# Donald C. Cook Nuclear Plant Units 1 and 2 ANNUAL ENVIRONMENTAL OPERATING REPORT

ATTACHMENT TO C0401-10  
ANNUAL ENVIRONMENTAL OPERATING REPORT

## **Annual Environmental Operating Report**

**ATTACHMENT A**  
**SGRP ENVIRONMENTAL REVIEWS**

# Haul Route Modification

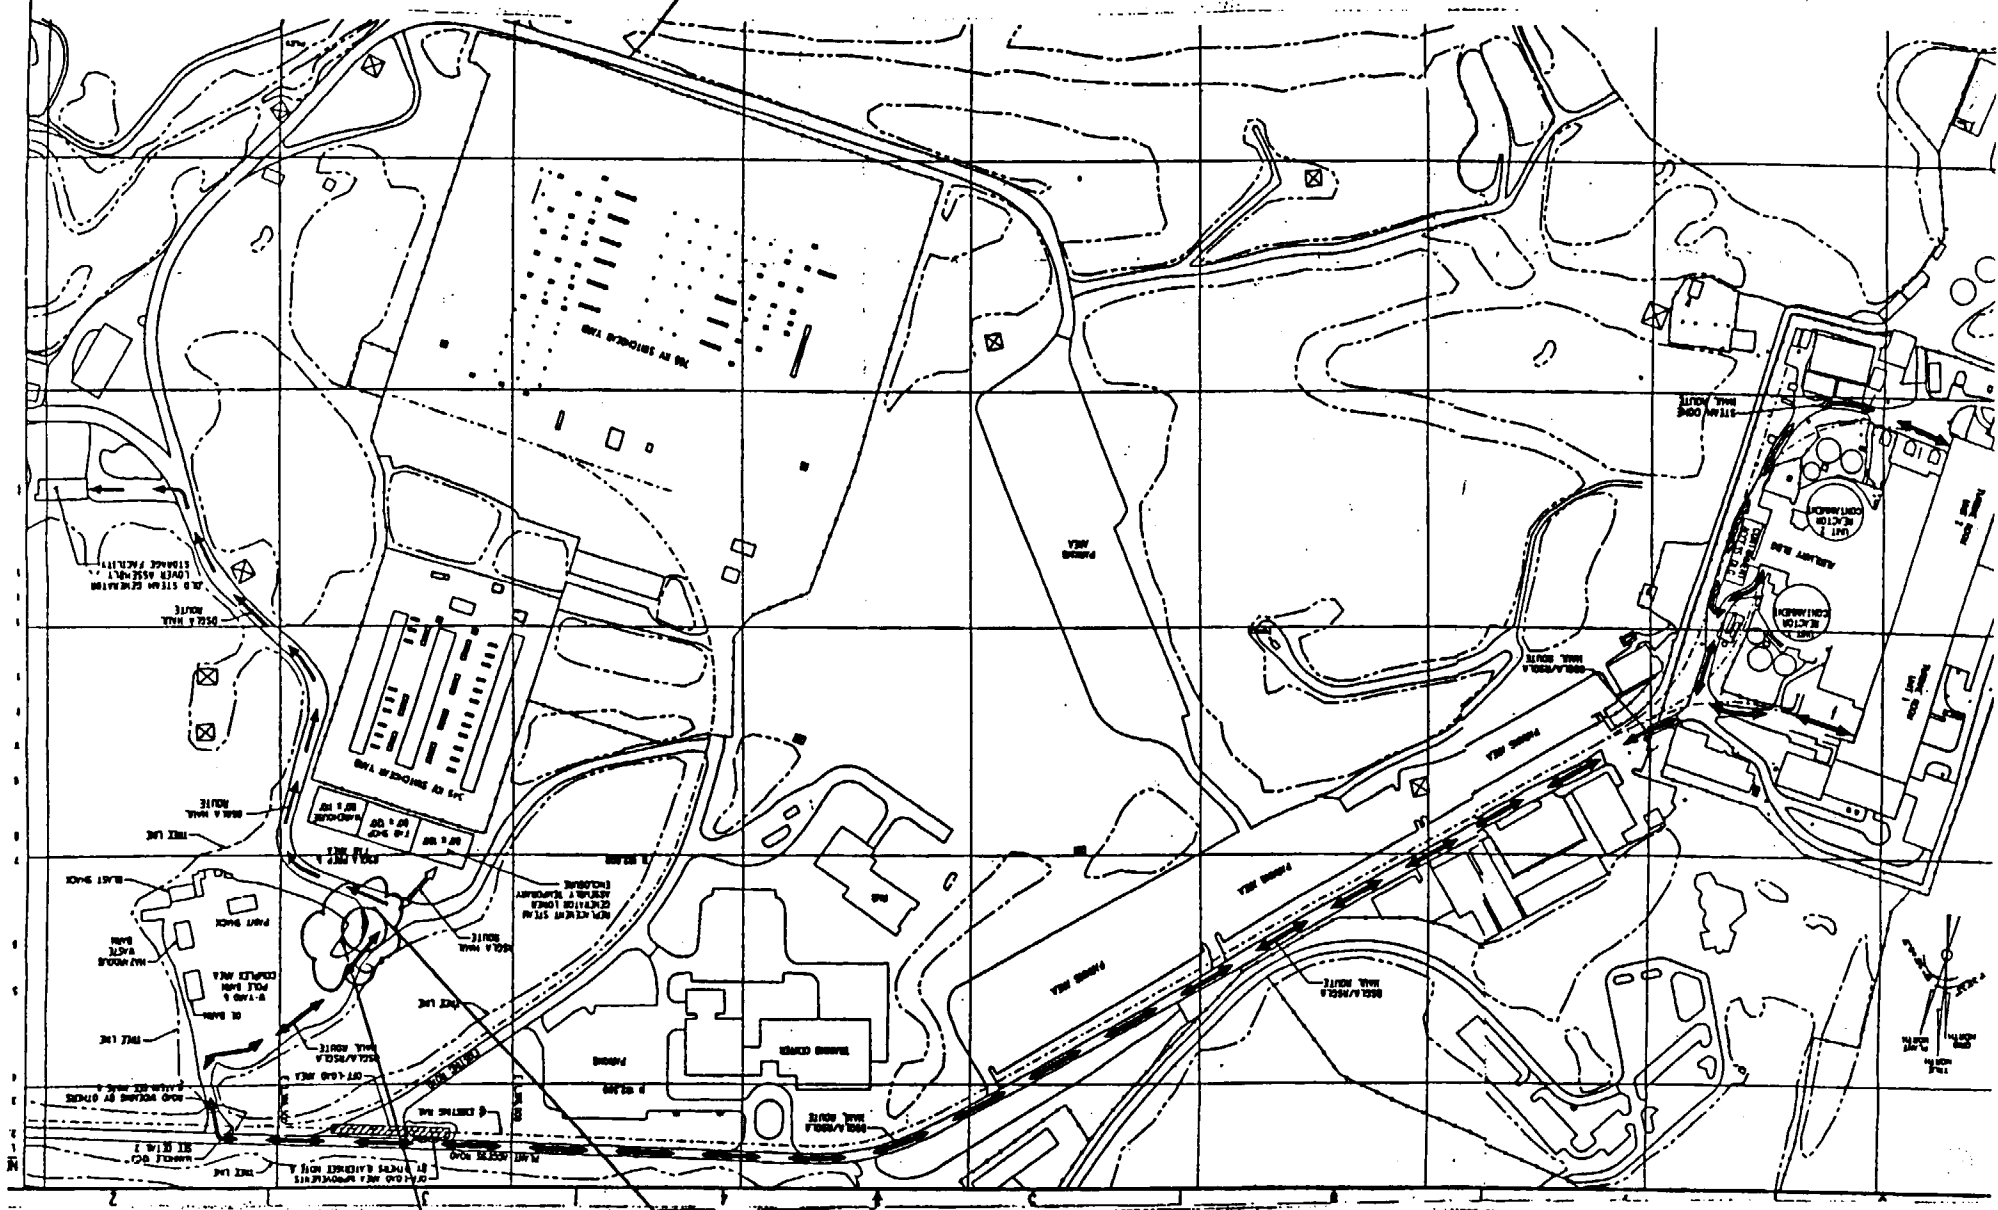
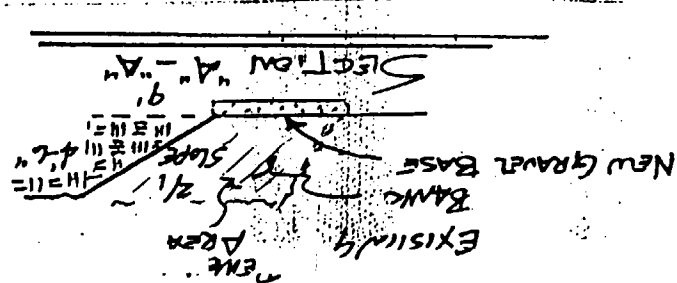
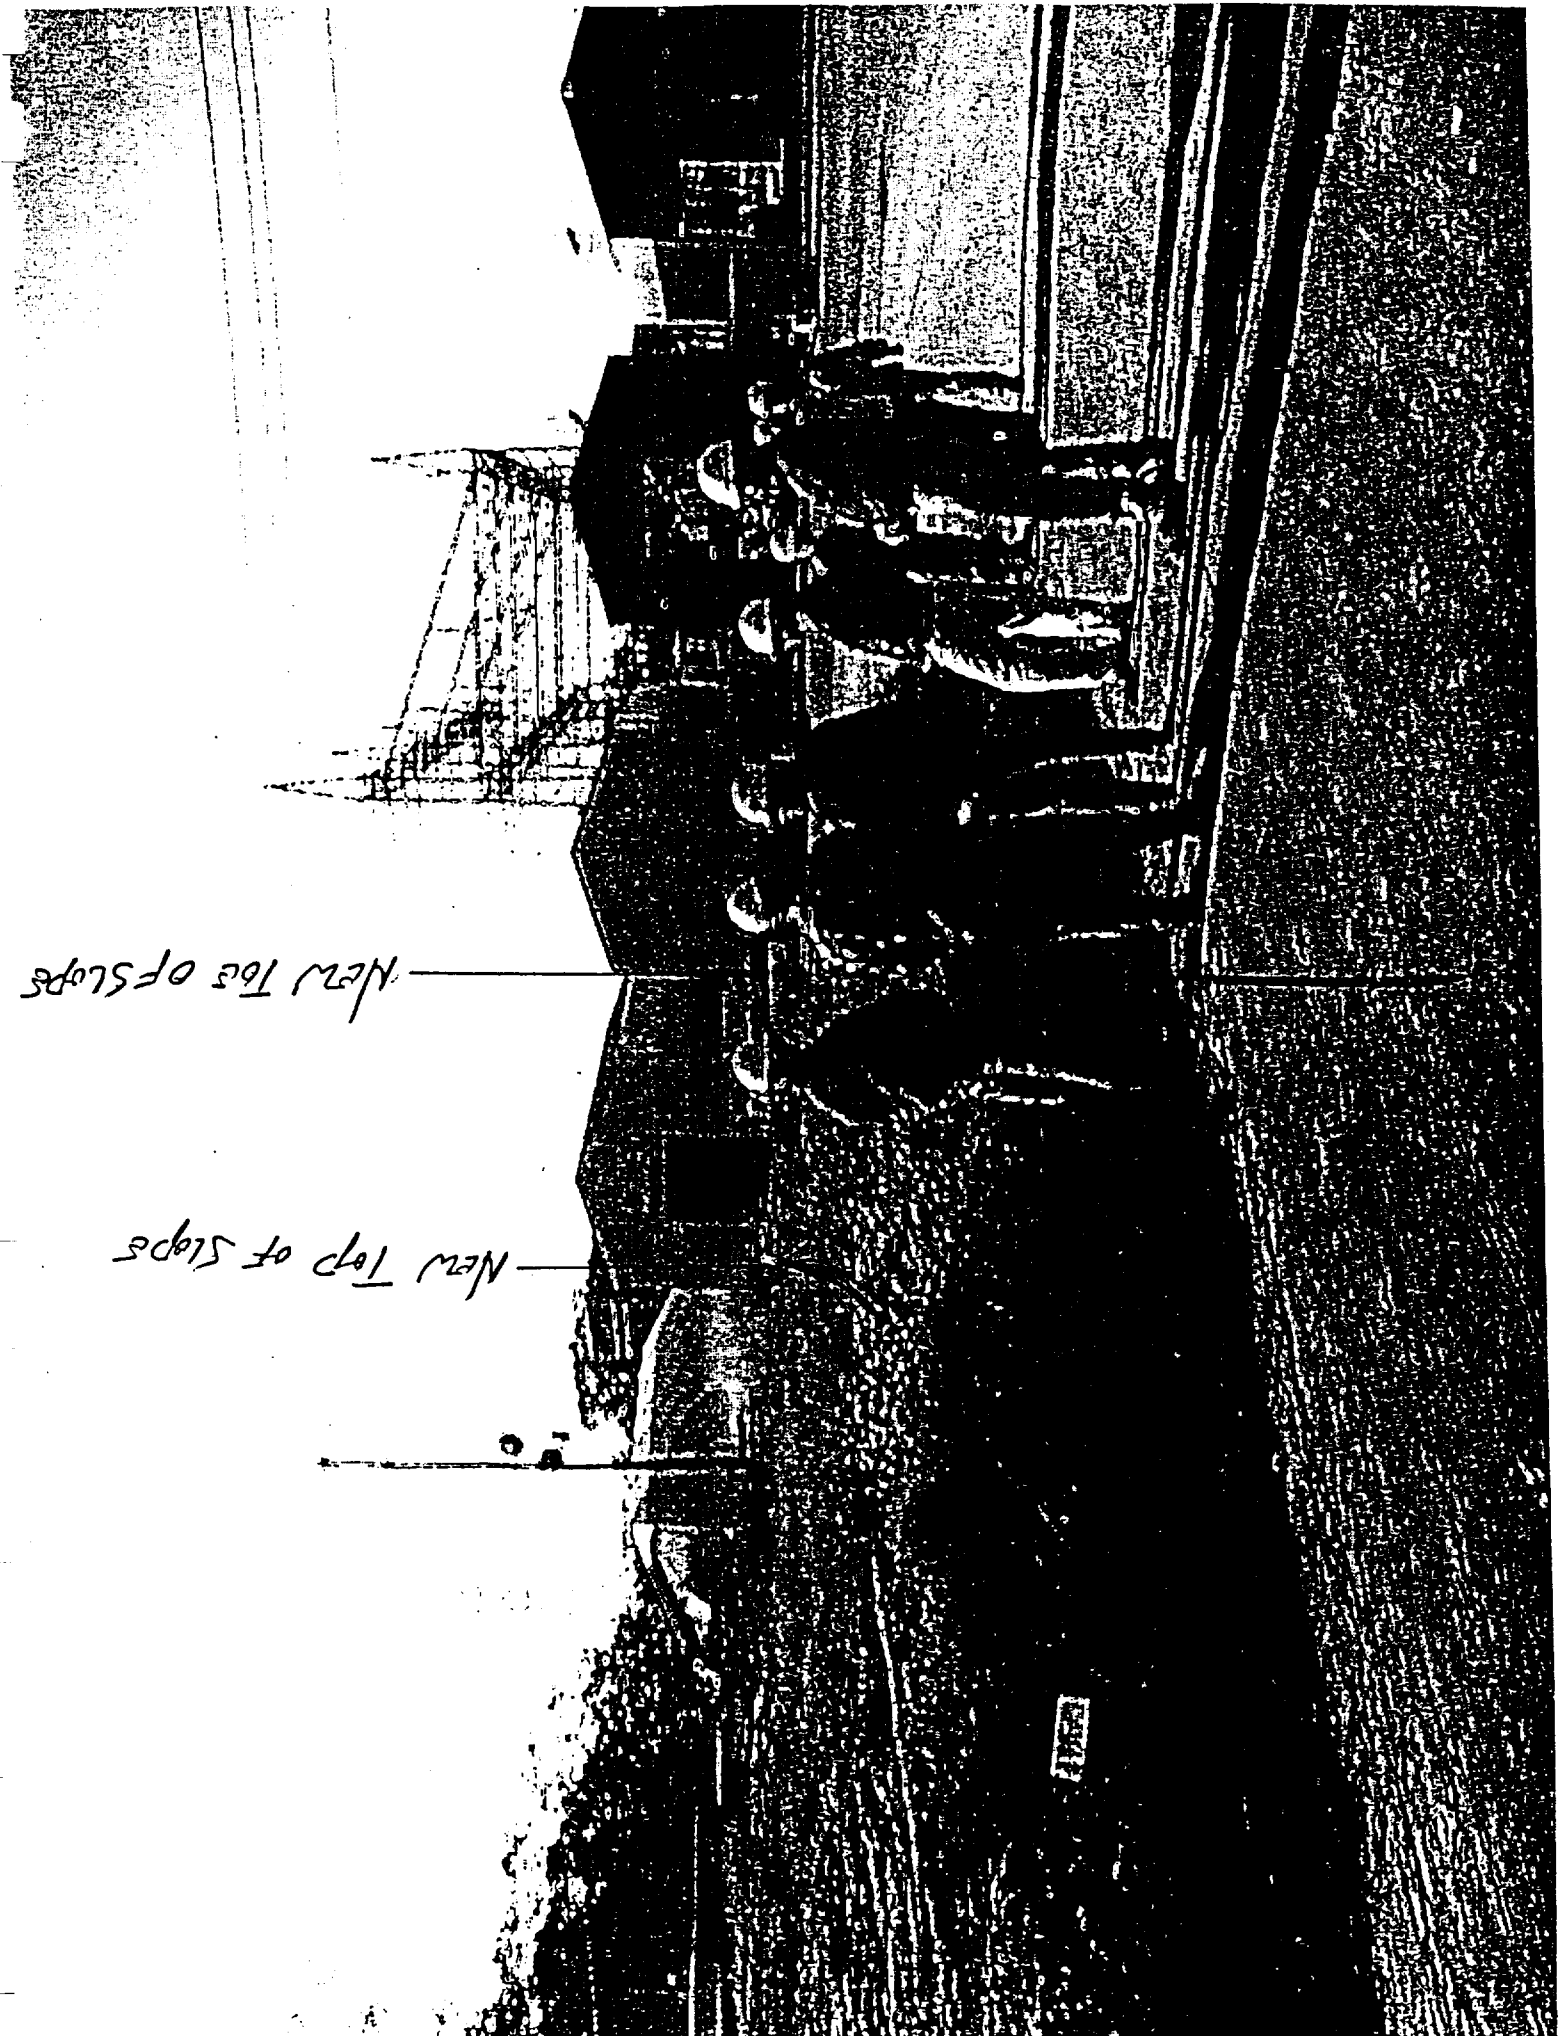
Perform work as described in attached drawing

EAST APPROX 12' OF  
 PLACE EROSION  
 FABRIC ON NEW  
 2/1 SLOPE.

ATTACHMENT TO ENV. PERMIT  
# FOR LDGP 310

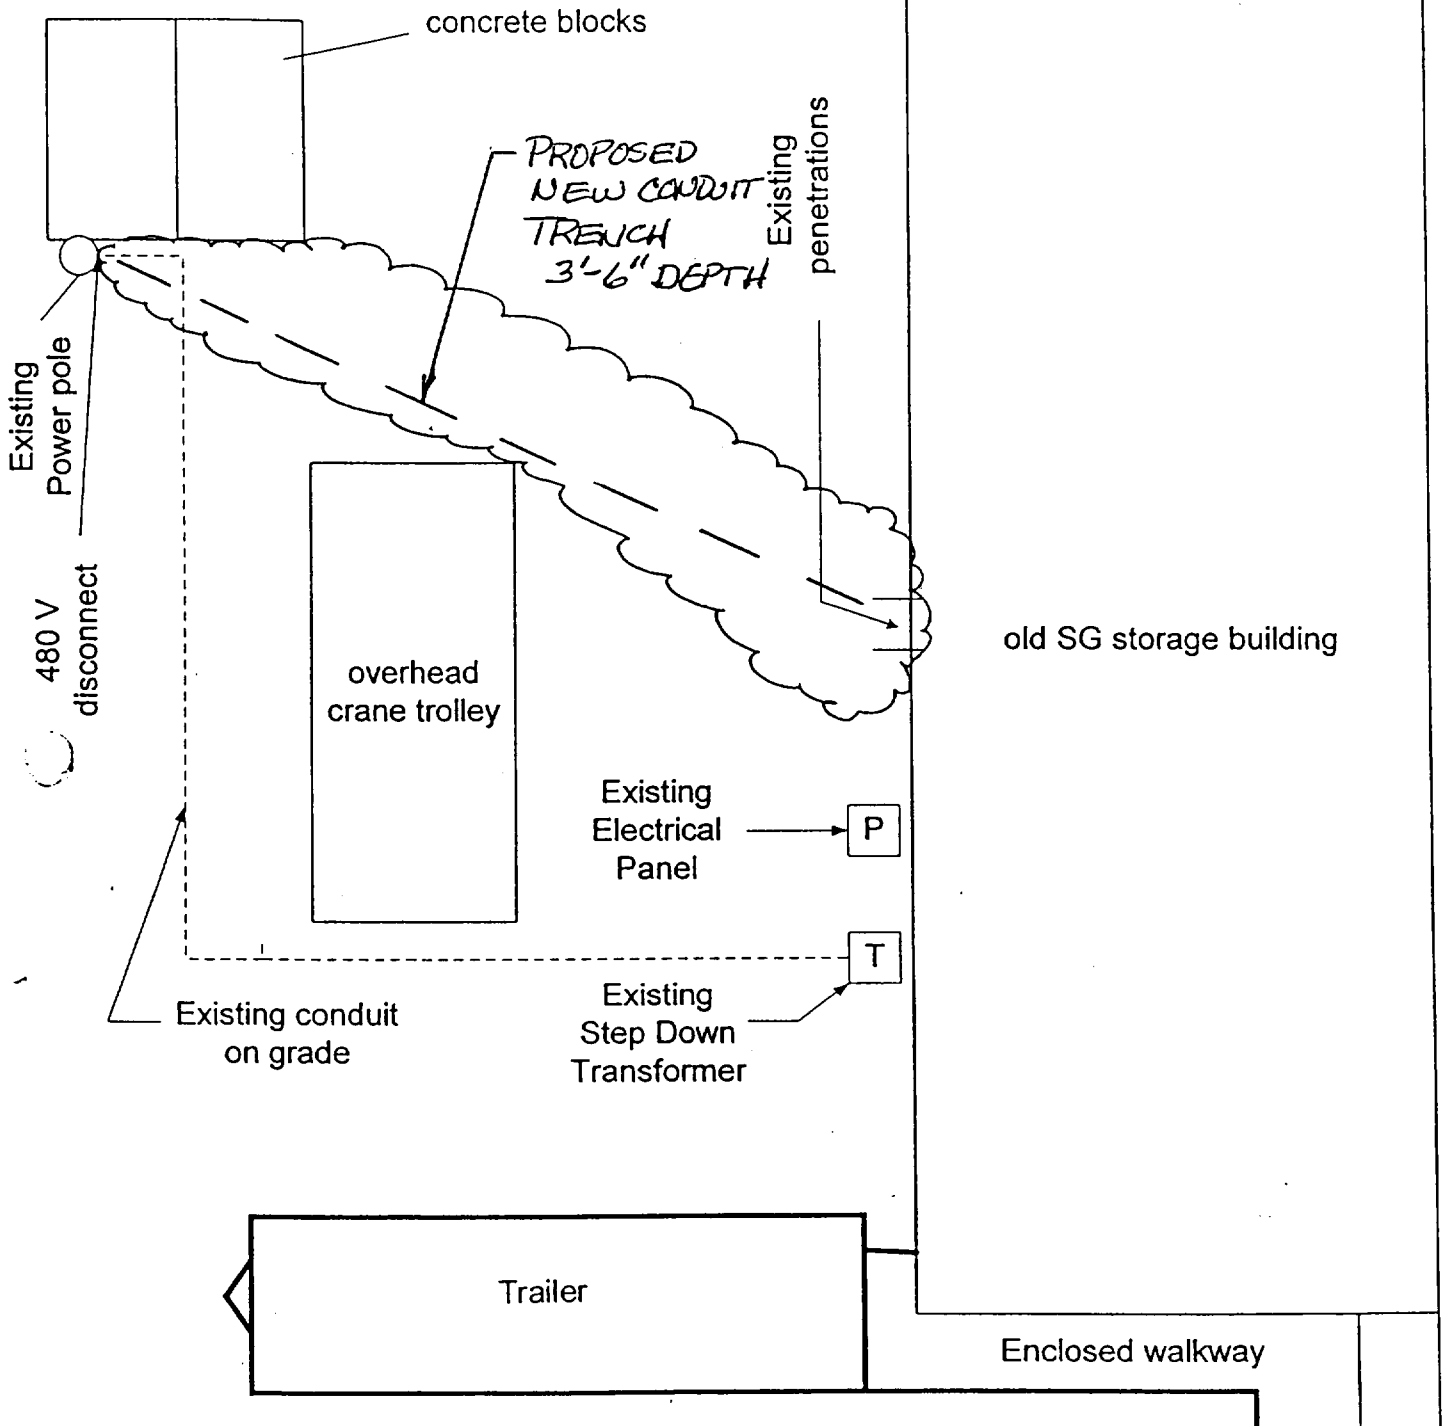
prevent soil erosion during trenching. Protect nearby Creek  
from silting - should be prevented by vegetation established  
down bank from the site and the creek.
